AP1000 DCD SER Open Item REVIEW

OI Response Number: OI-SRP19.0-SPLA-12 Revision: 23

Determination and Documentation of Test Required Response Spectra for AP1000 Equipment Requiring Seismic Margin to meet NRC ISG DC/COL-ISG-020

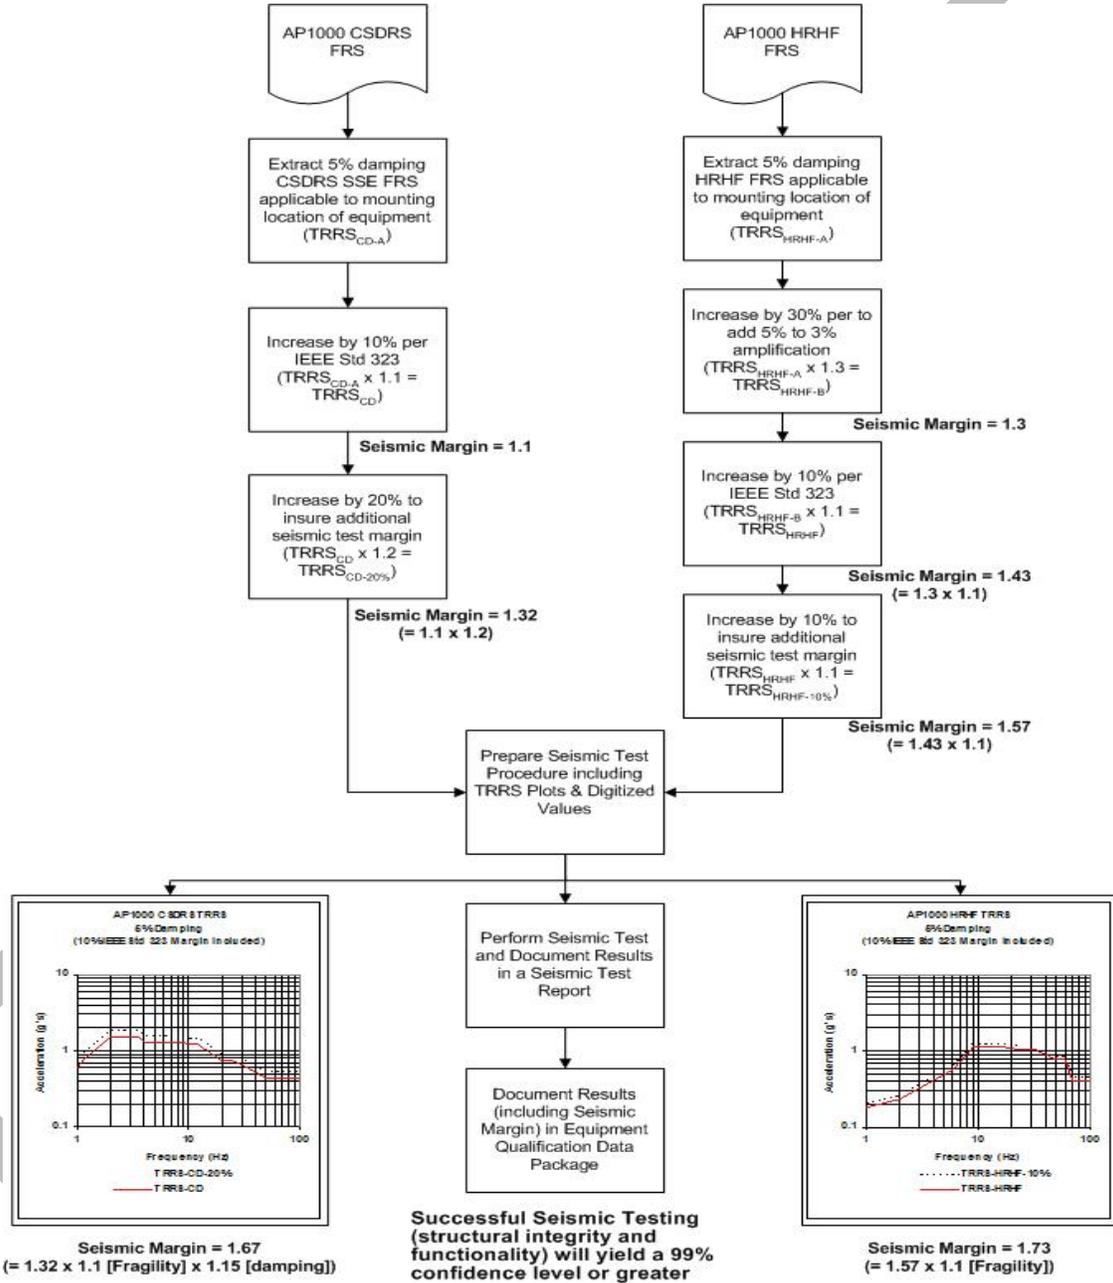
Confirm that an acceptable seismic margin is maintained for HRHF sites.

- a. Description of the seismic margin associated with seismic testing employing a 3% critical damping response spectra and tested/analyzed at 5% critical damping will be provided. Reference will be made to the technical criteria (WCAP or EPRI document) for changes amplification factors as a function of damping and the need for maintaining the peak to zero period acceleration (ZPA) ratio.
- b. An illustration will be provided to show the test required response spectra (TRRS) will include 10% margin . The illustration should indicate and clarify that 10% margin is not being "double counted."
- c. Illustrations will be provided to show the test response spectra (TRS) used to demonstrate acceptability envelope the TRRS with margin.
- d. Provide quantitative plots that are representative of the margins in testing.
- e. Describe the testing margin in the DCD.

Combining the seismic margin contributing factors for Design Basis HRHF sites noted above results in a seismic margin factor in the range of 1.73 to 1.97. An example of using the above seismic margin factors (except for the fifth bullet) is shown in Figures 1 and 2. The above seismic margin contributors (except for the first bullet) are also applicable to demonstrating the seismic capacity level of at least 1.67 for the CSDRS design basis. Therefore, based on the above there is sufficient seismic margin associated with the CSDRS qualification process and the HRHF screening for potential high frequency sensitive equipment to demonstrate compliance with the 1.67 factor recommended in References 2 and 3.

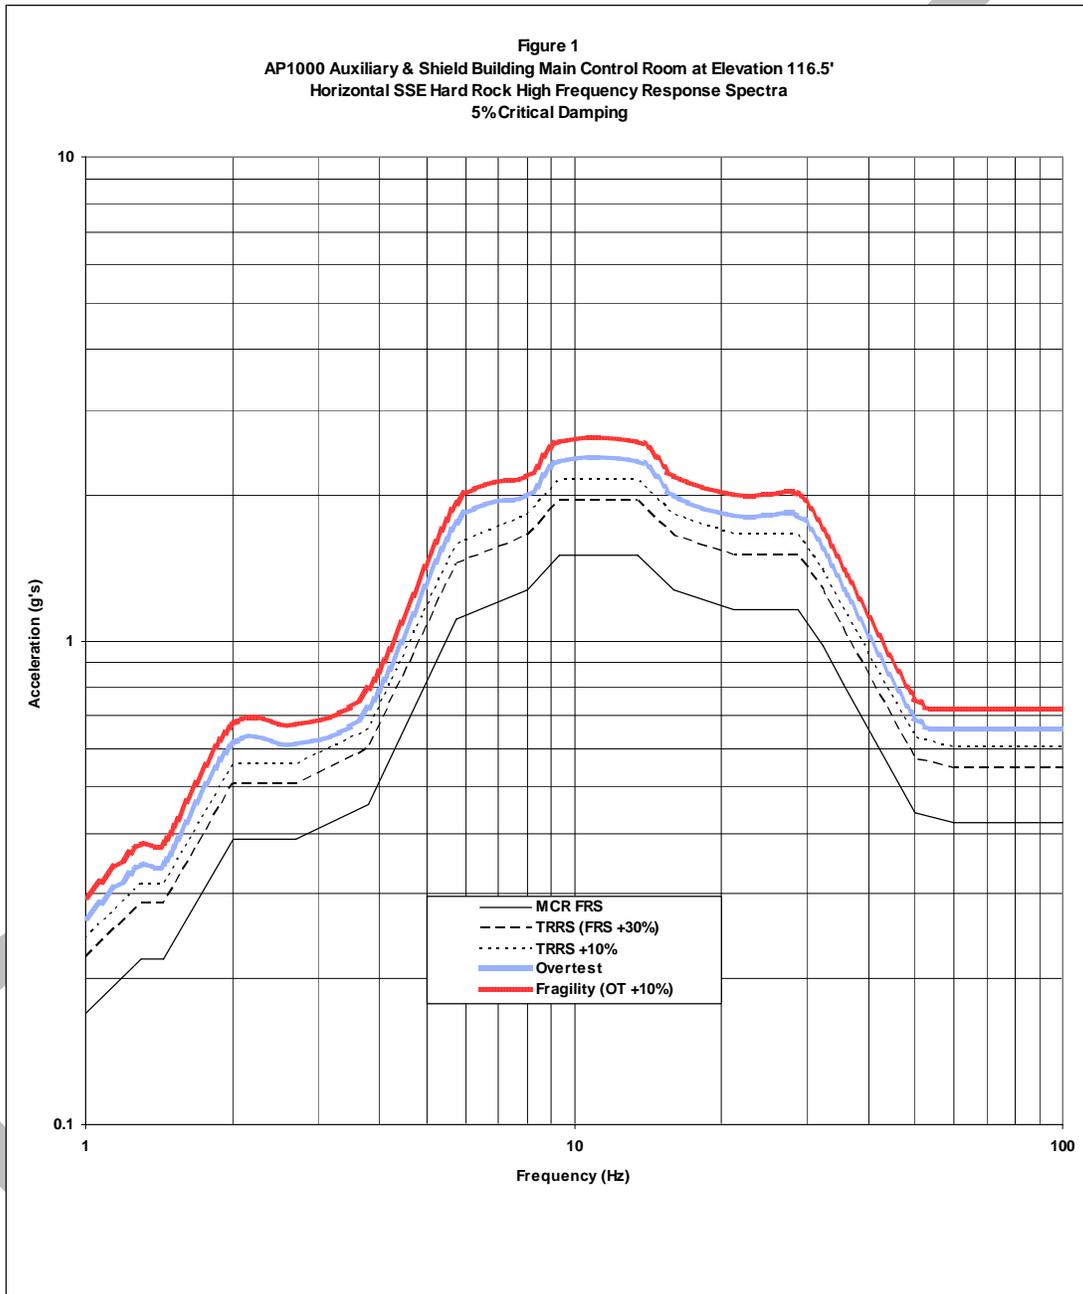
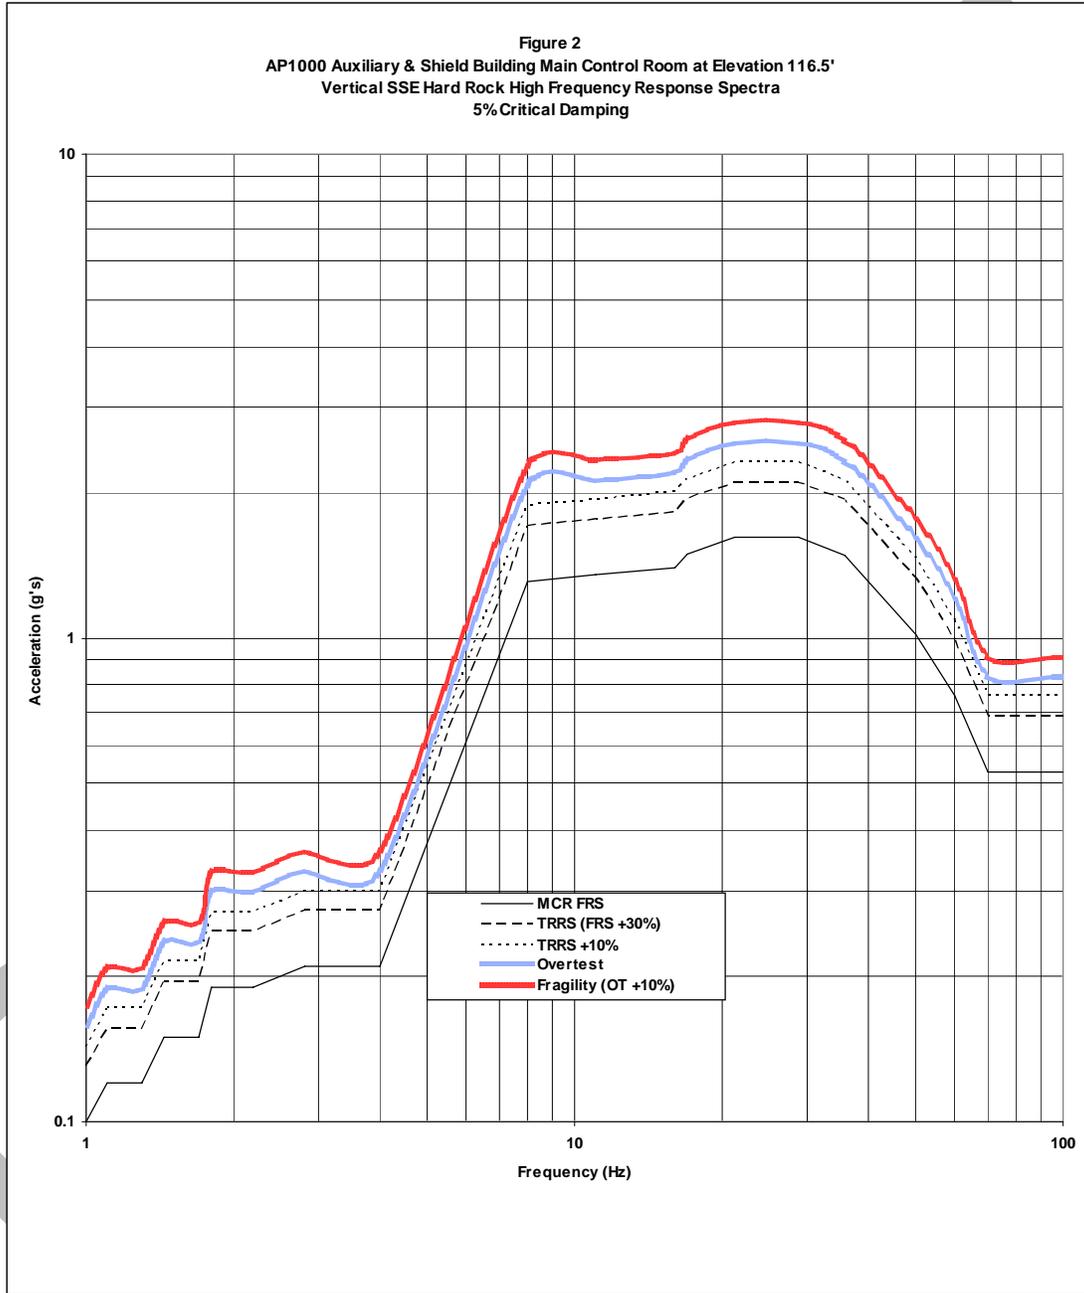
There is concern from the NRC staff that we are not going to be in full compliance with ISG-20 when it is issued in final form. The NRC has requested that we provide a documented process for how we will ensure that we maintain the 1.4 factor as defined in ISG-20.

Please see attachment A for the requested process for Seismic Margin verification in Seismic Testing. There are no DCD mark-ups specified in this revision but the track changes are being maintained to see what changes have been made to the DCD in Rev. 2.
